MELBOURNE METRO RAIL PROJECT ENVIRONMENT EFFECTS STATEMENT
INQUIRY AND ADVISORY COMMITTEE

MMRA TECHNICAL NOTE

- TECHNICAL NOTE NUMBER:** 009
- DATE:** 26/7/2016
- PRECINCT:** Western Portal
- MAP BOOK REFERENCE:** Map 2 (Horizontal Alignment Plans – Construction Phase)

- SUBJECT:** Western Portal Option A - Construction of a temporary access ramp for the Lloyd Street Business Park between Tennyson Street and McClure Road

- A. Annotated EES Map 2 (construction phase) showing Lloyd Street Business Park – proposed access ramp location

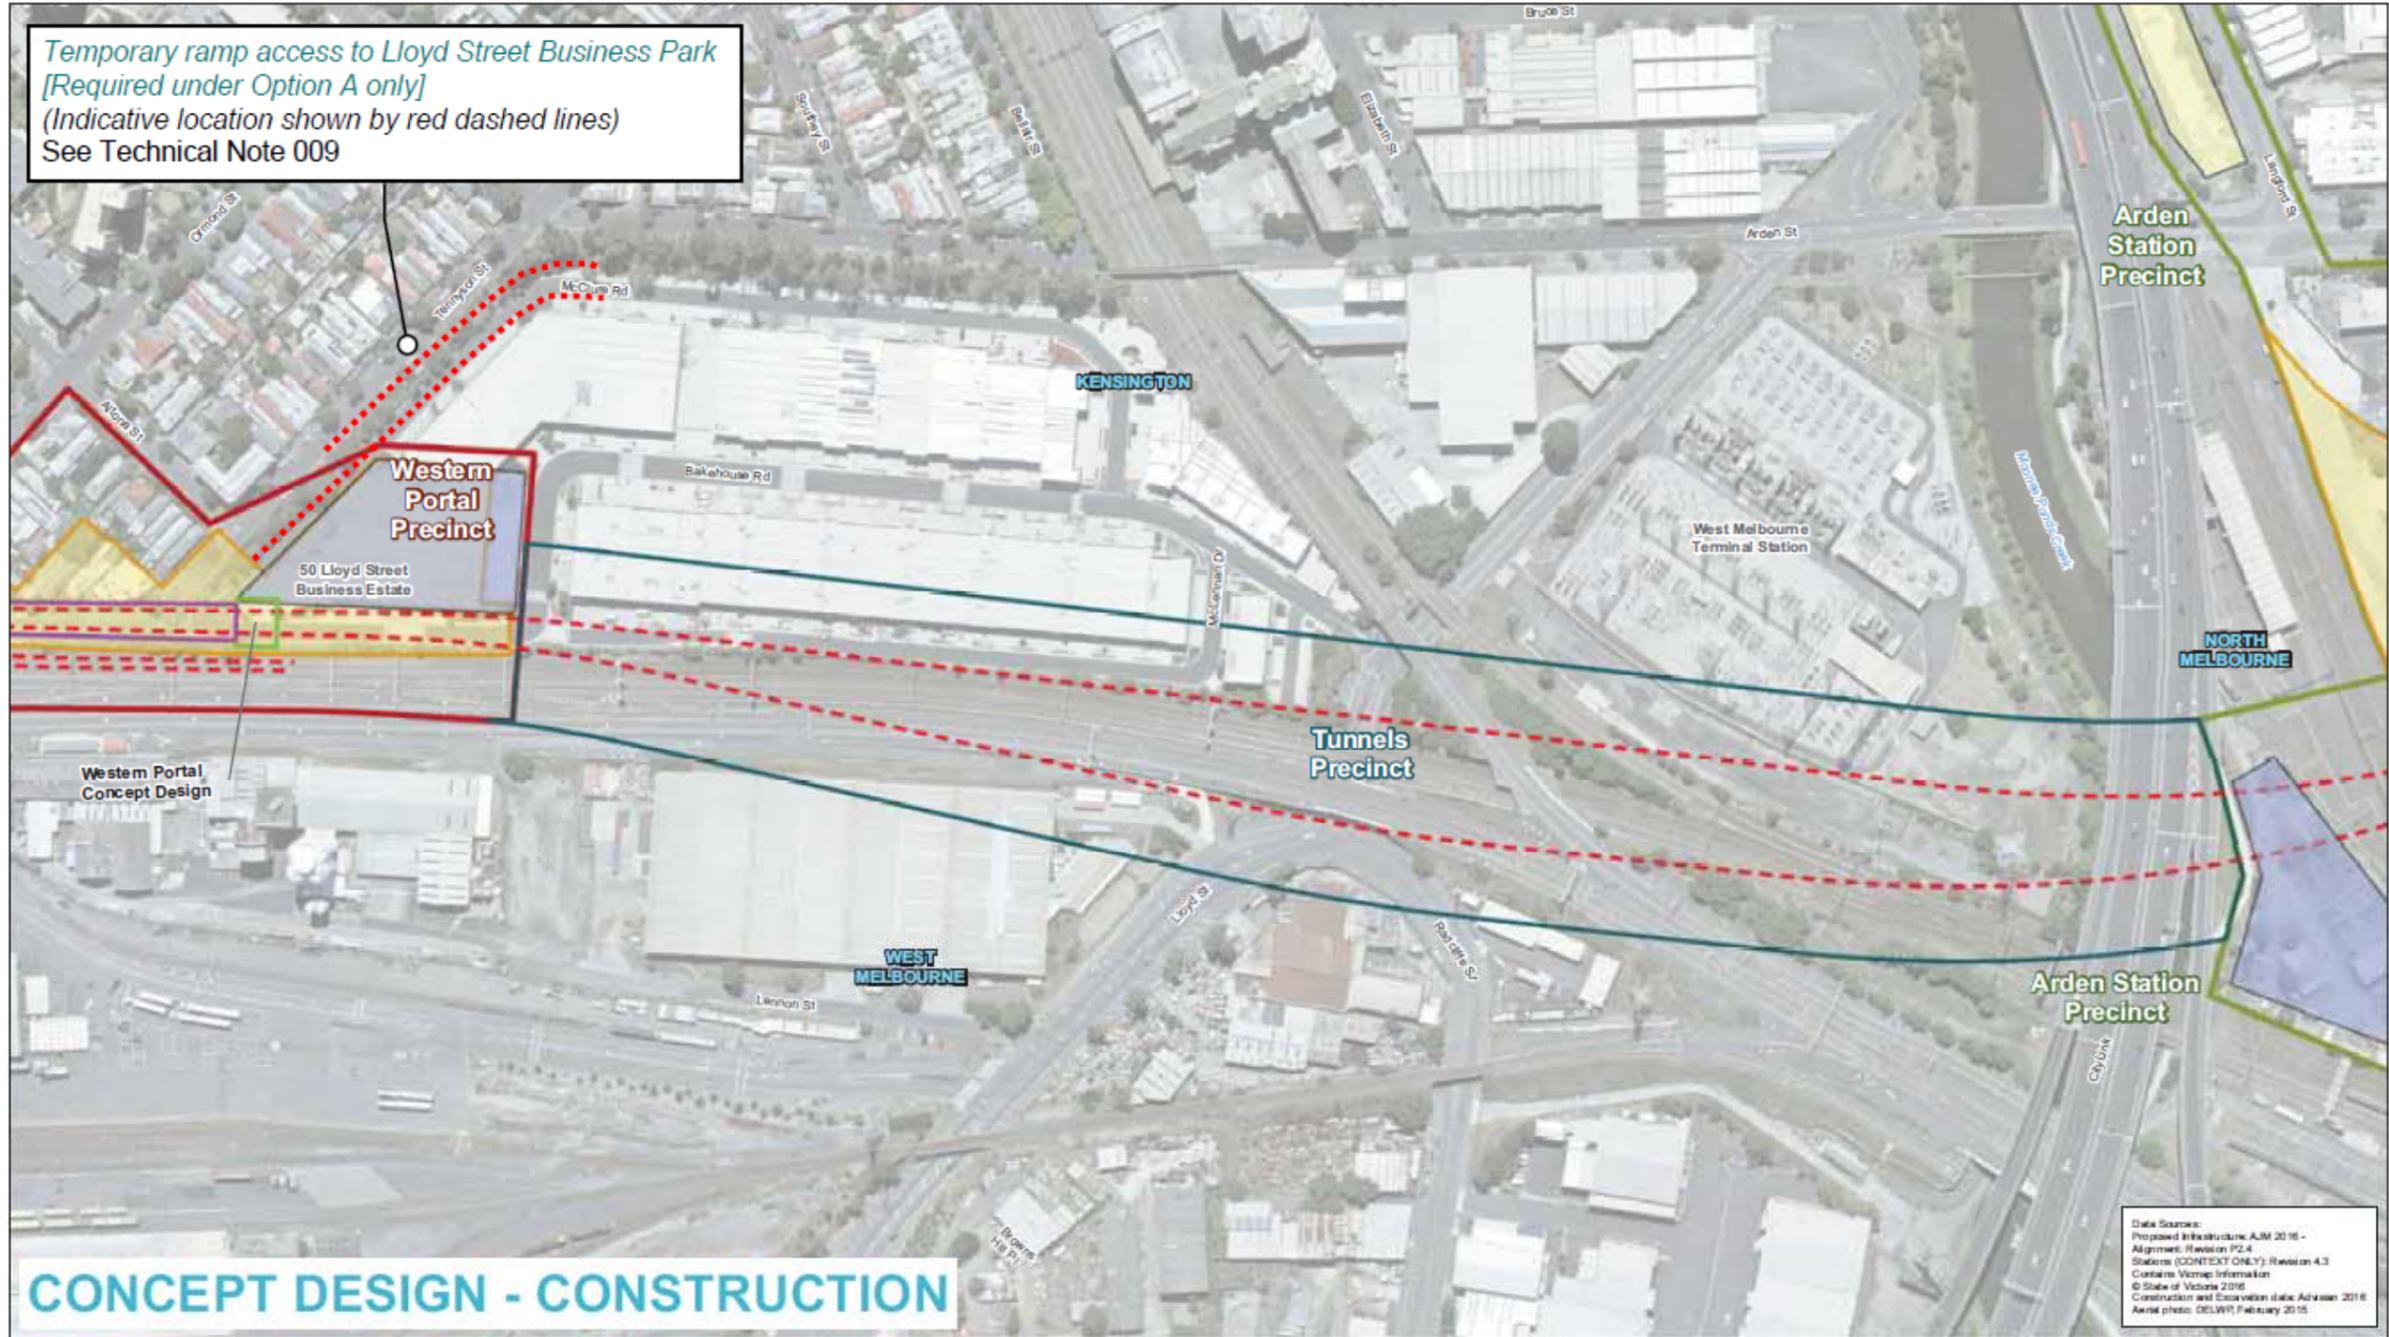
5. For Western Portal Option A only, access to the Business Park for vehicles higher than 3.1m must therefore be maintained from the west of the Business Park (refer Attachment A).

6. Further analysis and consultation with the Business Park tenants has identified that access for oversized vehicles would need to be provided during the construction of Western Portal Option A. This access would be from the west as an alternative entry into the Business Park from

Tennyson Street, when the existing access from Childers Street is unavailable.

7. All traffic for the Business Park from the west is proposed to be managed through Childers Street, and diverted via Ormond Street and Altona Street to Tennyson Street.
8. A temporary access ramp between Tennyson Street and McClure Road that was not identified within the EES is therefore proposed as a solution for oversized vehicles to access the Business Park in respect of Western Portal Option A.
9. The need for the temporary access ramp does not arise in the case of Western Portal Option B.
